Public Service Company of Oklahoma
Black Fox Station Units 1 and 2
Miscellaneous Clarifications:
 Containment Elevator
 Ultimate Heat Sink Cooling Towers
Docket STN 50-556
 STN 50-557

November 10, 1978
File: 6212.125.3500.32 L

Enclosed are 40 copies of PSAR Figure 14.16a showing the containment elevator pit framing. This drawing represents the current BFS design in this area and supercedes PSAR Figure 14.16a dated 12-100678 found on page 3C.14-17a.

9.2.5.3 Safety Evaluation. The Ultimate Heat Sink is capable of providing sufficient cooling for more than 30 days:

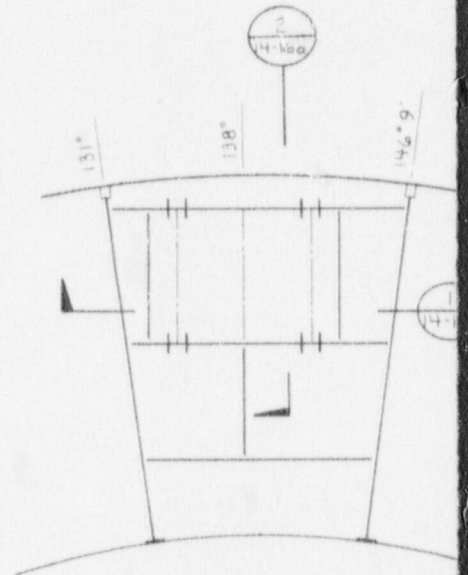
In addition, enclosed are 40 copies of PSAR page 9.2-11 representing the current PSO position regarding the UHS Cooling Tower design.

The Ultimate Heat Sink in conjunction with the SSWS is designed to withstand, without loss of safety function, the disabling of any one cooling tower fan simultaneous with a single active failure in any one Unit 1 or Unit 2 division during a loss of preferred power. The Unit 1 Division 1 and Division 2 SSWS return lines to the UHS cooling towers will be cross-tied to the respective Unit 2 SSWS return lines.
